**TOWN OF BAY HARBOR ISLANDS
PLANNING AND ZONING BOARD**

TOWN OF BAY HARBOR ISLANDS COMMUNITY DEVELOPMENT MEMORANDUM

Subject: Site Development Plan Application – Revisions 2020
9350 Bay Harbor Terrace Townhouses (6 DU)
9350 Bay Harbor Terrace
Revisions to Exterior Building Façade / Interior Revisions
Ground Floor FEMA Revisions / Add 4th Floor / Revise Roof Level
Bay Harbor Islands Acct. No. MB2015-79
MMPA Acct. No. 01-0702-1003

MMPA recommends the Planning and Zoning Board (PZB) review the most recent revised plans prepared by George E. Peon Architect, A.I.A. last revised June 1st, 2020 and, if found acceptable, **APPROVE** the proposed Site Development Plan revisions subject to the recommended staff conditions listed hereinafter.

EAST ELEVATION-FRONT
SCALE: 3/16" = 1'-0"

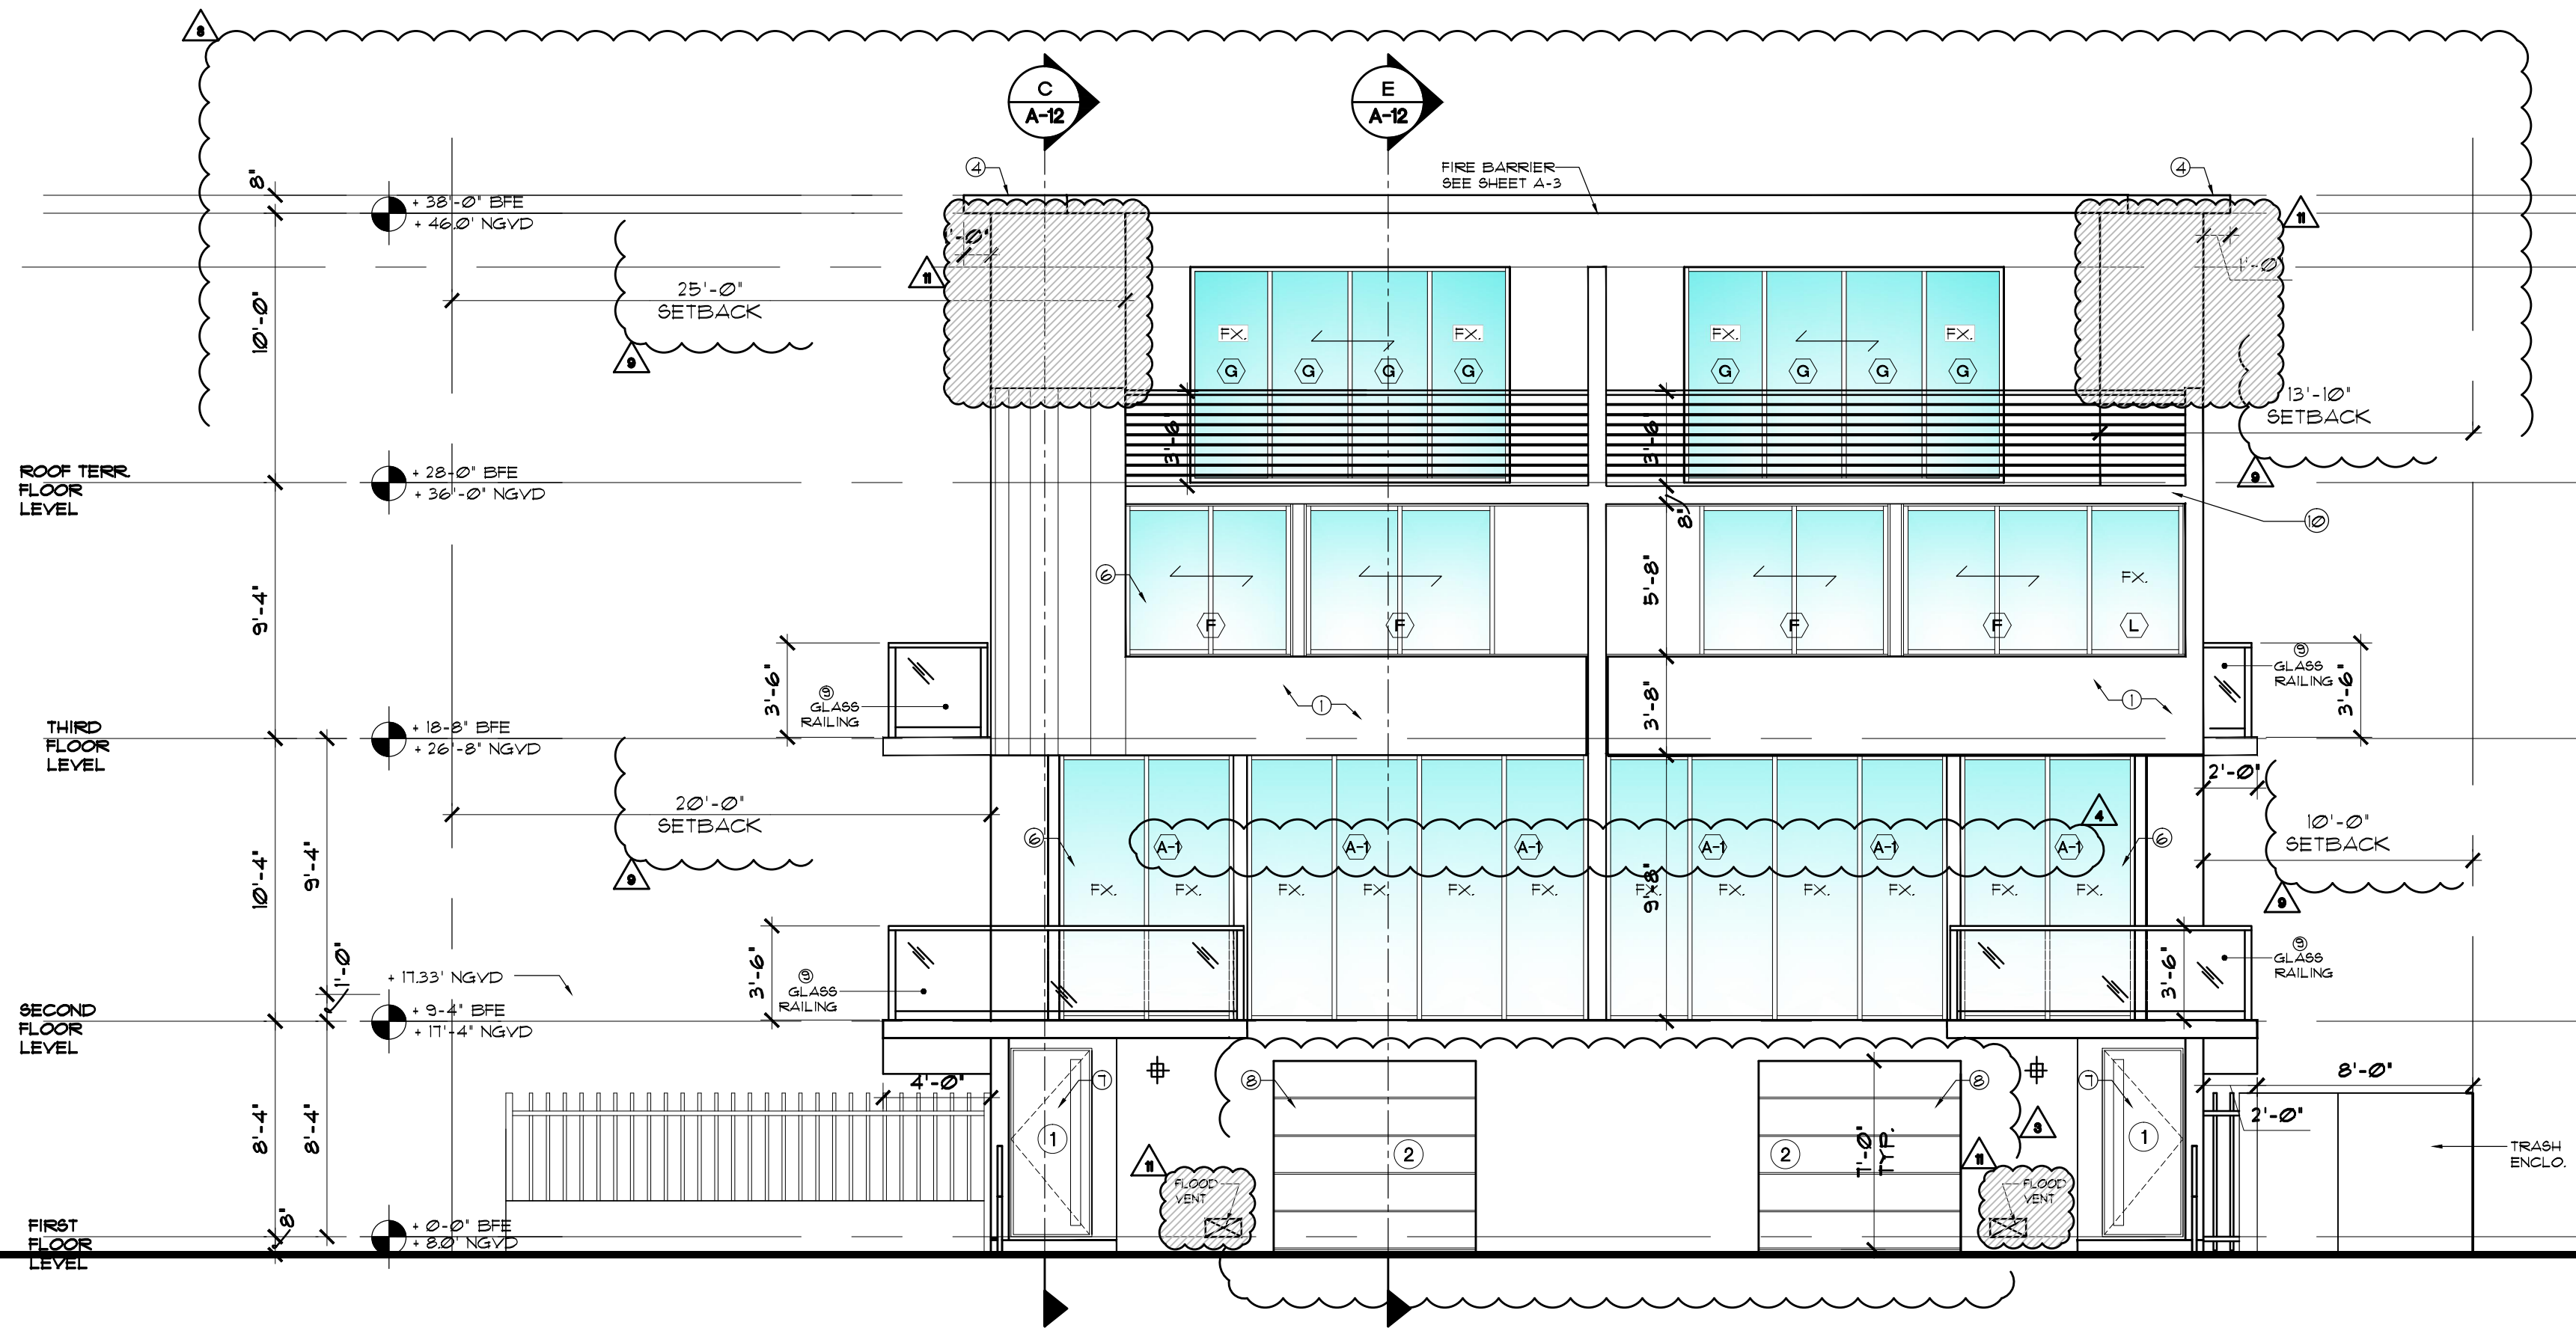
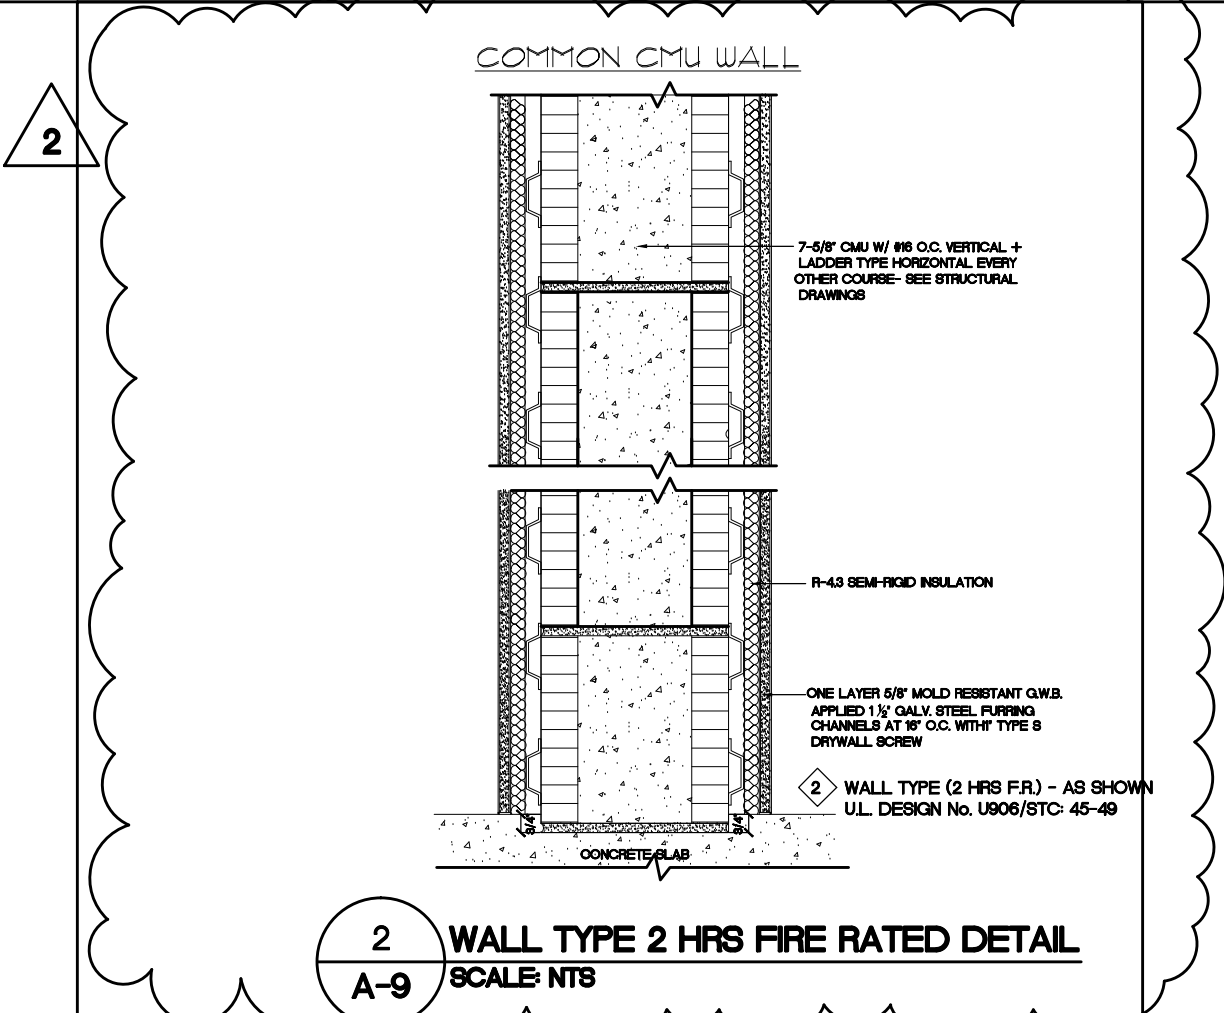
building over 30' BFE, the East Elevation - Front (facing Bay Harbor Terrace) increased from 20' to 25'. For those portions of the building over 30' BFE, the North Elevation – Front (facing 94th Street) increased from 20' to 25'. For those portions of the building over 30' BFE, the West Elevation – Side increased from 10' to 13'-10". Finally, for those portions of the building over 30' BFE, the South Elevation – Rear increased from 10' to 13'-10". Those portions of the building below 30' BFE kept the original setbacks. Flex setback provisions were incorporated for some of the exterior elevators / stairs / other areas.

Partially due to adding the new 4th Floor a proposed revision is to close-in four (4) masonry openings on the east elevation at the 4th floor facing the street. The four (4) masonry opening are proposed to be closed-in with concrete block and decorative tile will be applied. These openings were in the original approved plans when the 4th floor was a proposed roof terrace. According to the applicant the proposed tile will look like natural wood. Attached is an exhibit which shows the proposed tile.

WEST ELEVATION-REAR
SCALE: 3/16" = 1'-0"

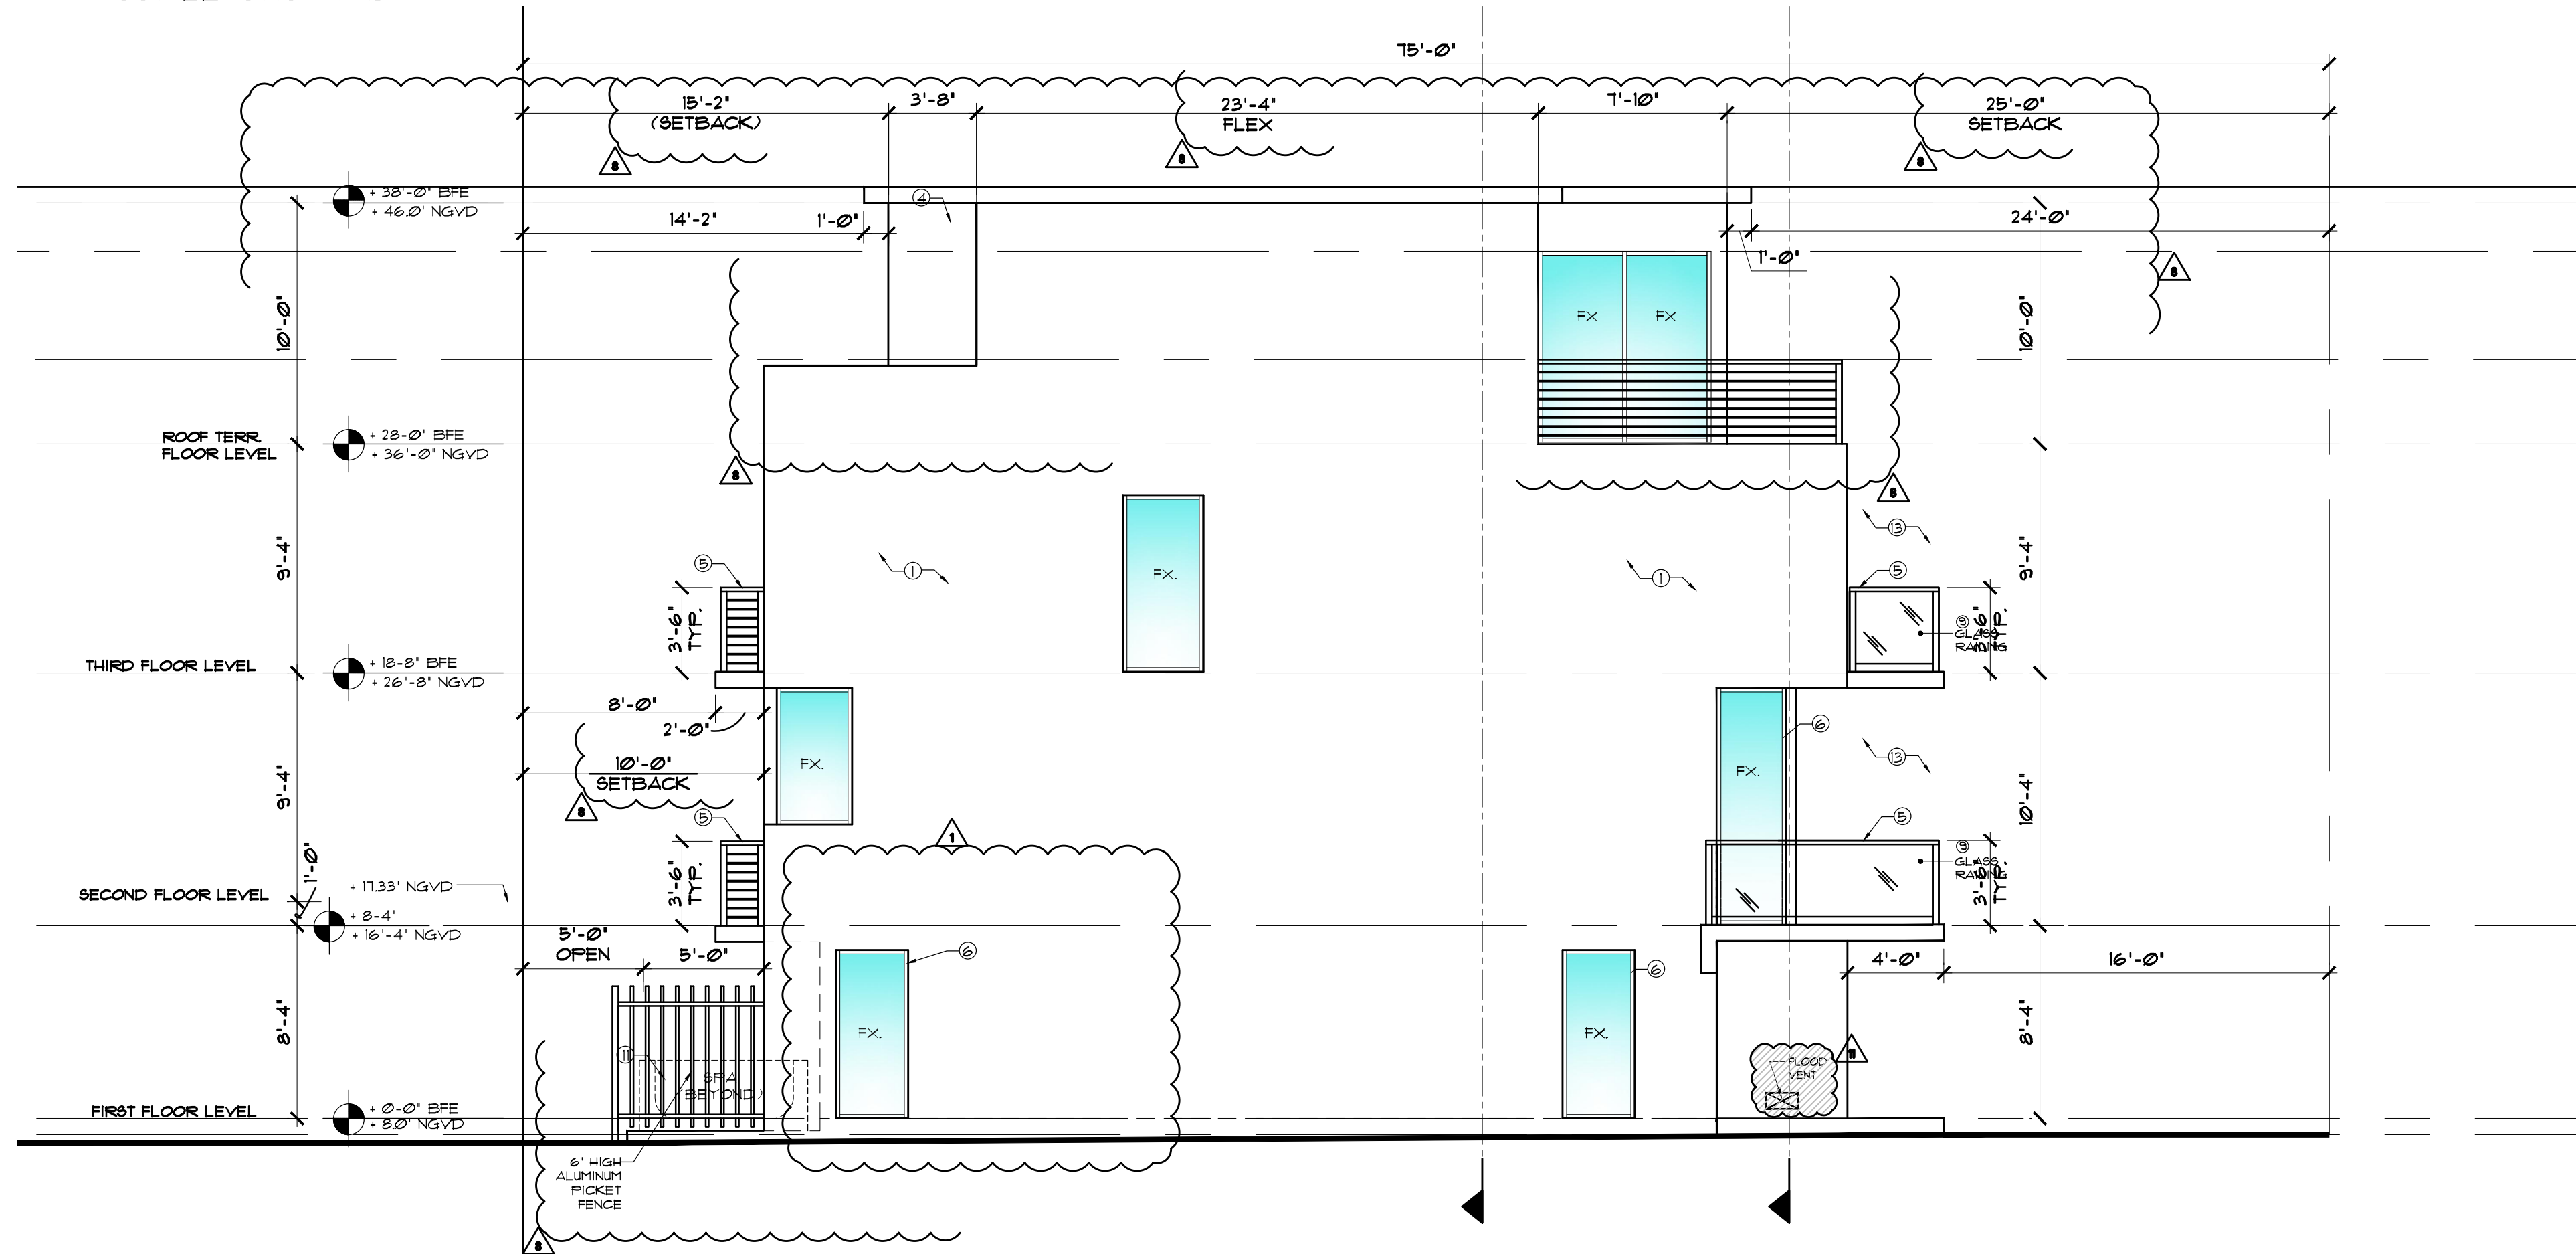
The proposed revision is to change the previous steel cable railings to glass panel railings on the north unit at the roof level. See Sheet A-10.

Four (4) exterior storage closet doors in the patio were deleted along the West Elevation. They were replaced with flood vents to address the FEMA / FBC issues. The ground floor is now only designed to have non-inhabitable uses.
